Wichita-Sedgwick County Metropolitan Area Planning Department

August 3, 2020

Re: **BZA2020-29: City Administrative Adjustment to reduce the front setback average by 20% of the front yard setback for building and site design on "LI" Limited Industrial zoning and B-Multi-Family zoning.**

C-02
site/
dimension plan

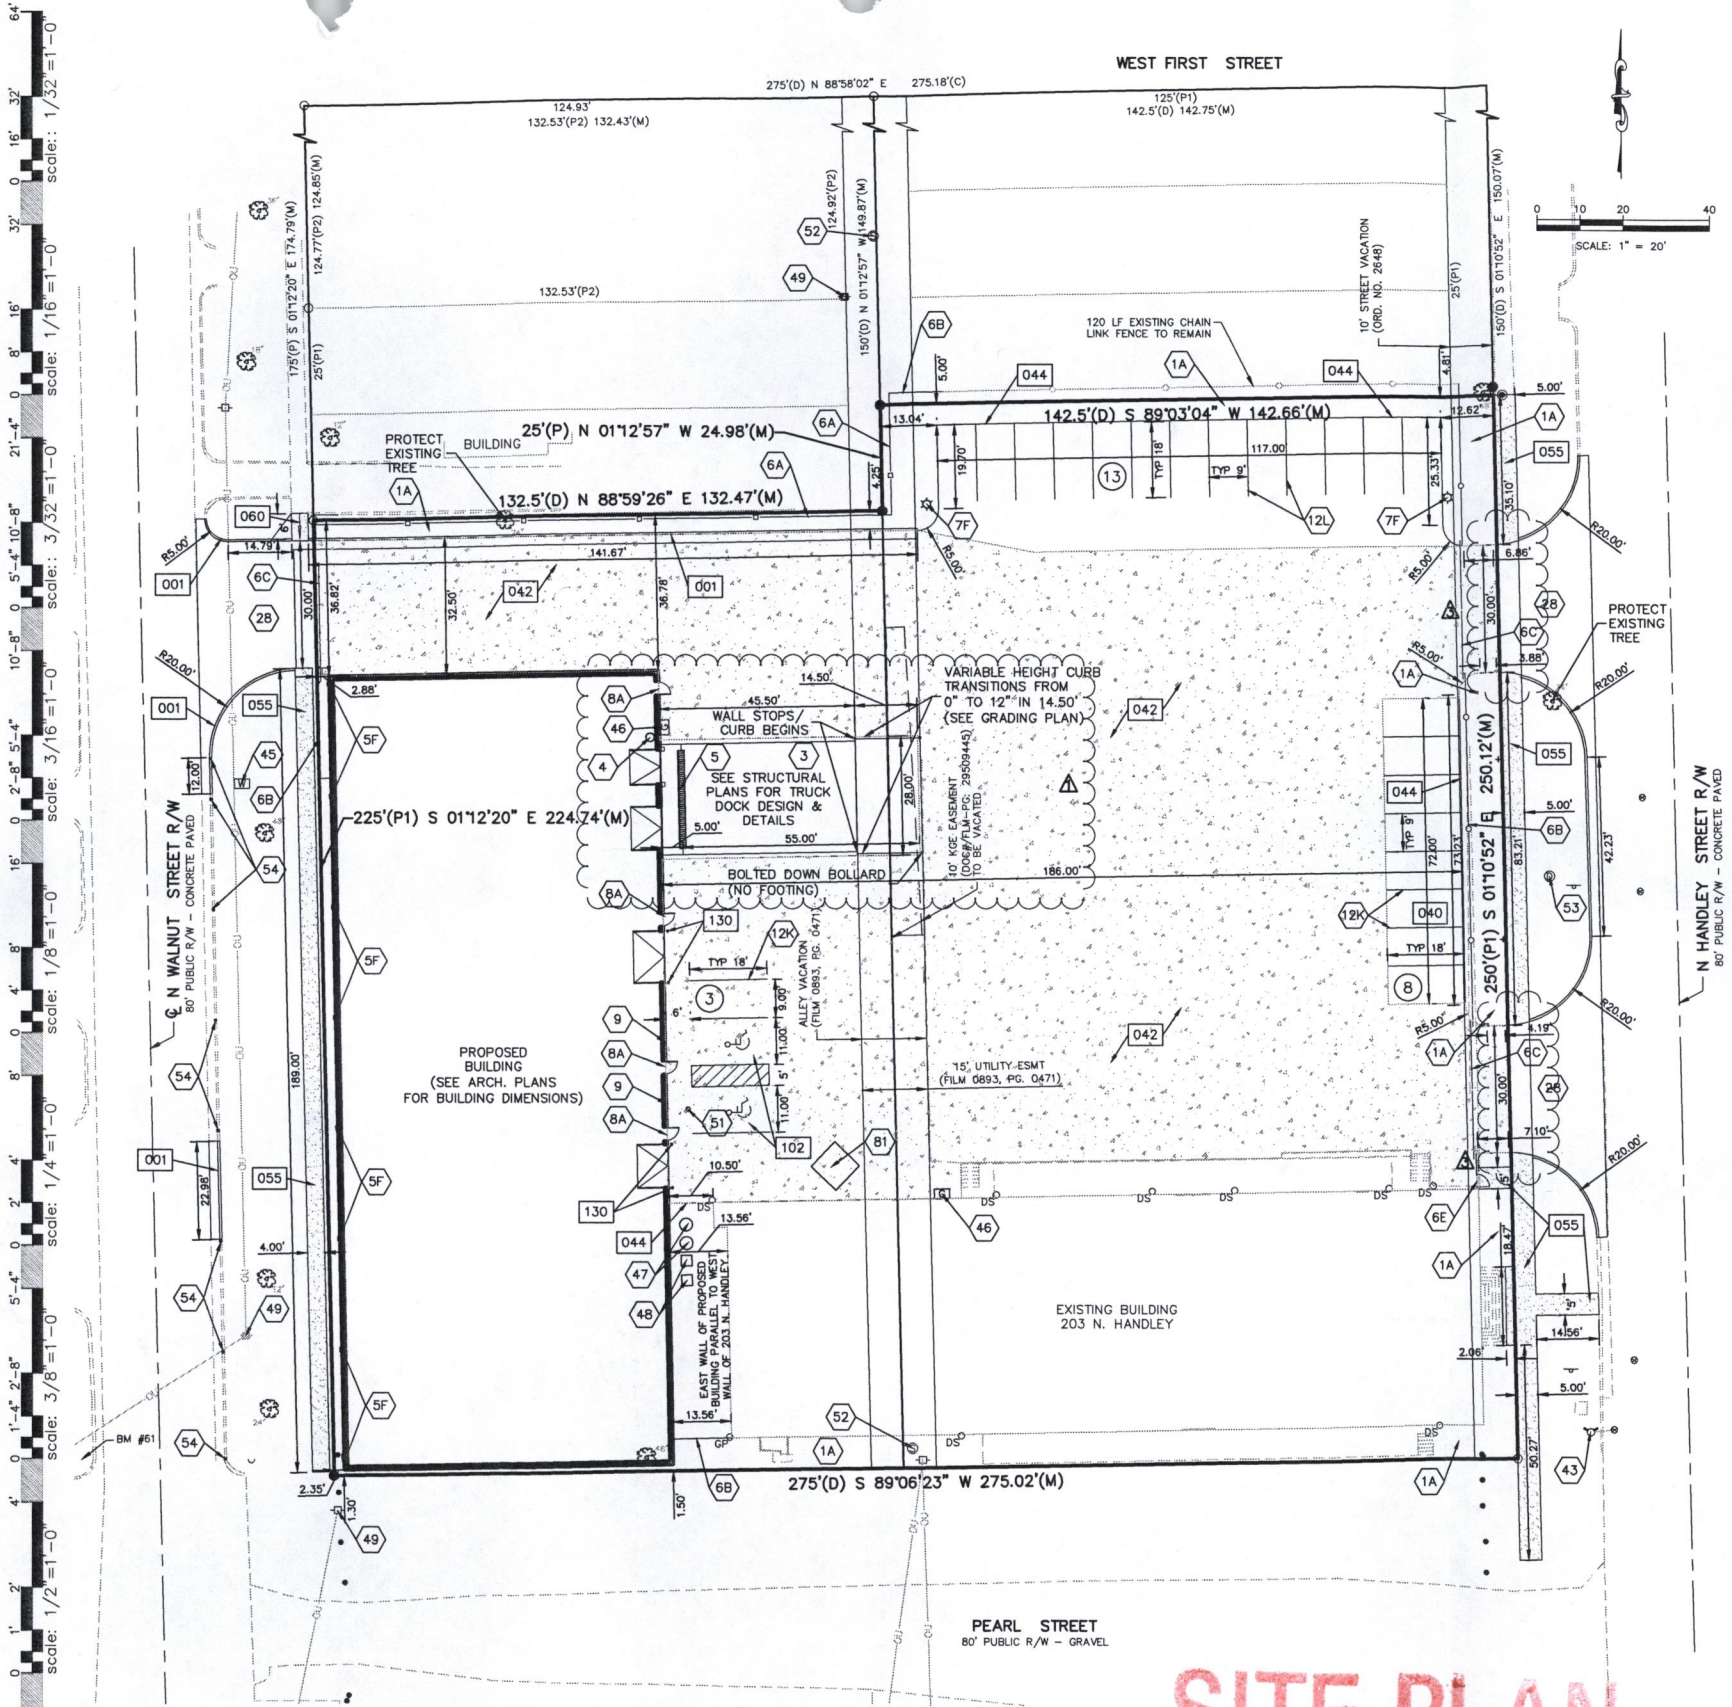
We reviewed your request for an Administrative Adjustment to reduce the average building setback along N. Walnut Street located between West Douglas Avenue and West 1st Street North, pending the zone change from B to LI. The average setback between W. Douglas and W. 1st Street is 32.83 inches. The applicant is requesting a 20% reduction of the front yard setback [Sec III-E.1.e.5(b)] to 26.27 inches as shown on the submitted site plan.

Our signatures below indicate that an Administrative Adjustment to reduce the front yard setback from 32. 83 inches to 26.27 inches as shown on the submitted site plan. is hereby granted, subject to the following conditions:

1) The pending zone change from B to LI shall be perfected before the Administrative Adjustment is granted.

2) The site shall be developed in general conformance with the approved site plan.

3) The adjustment shall apply only to the front yard setback average along North Walnut Street as illustrated on the approved site plan. All other structures or additions on the subject property shall conform to the locations and setbacks permitted by the Unified Zoning Code unless a separate Zoning Adjustment or Variance is granted.
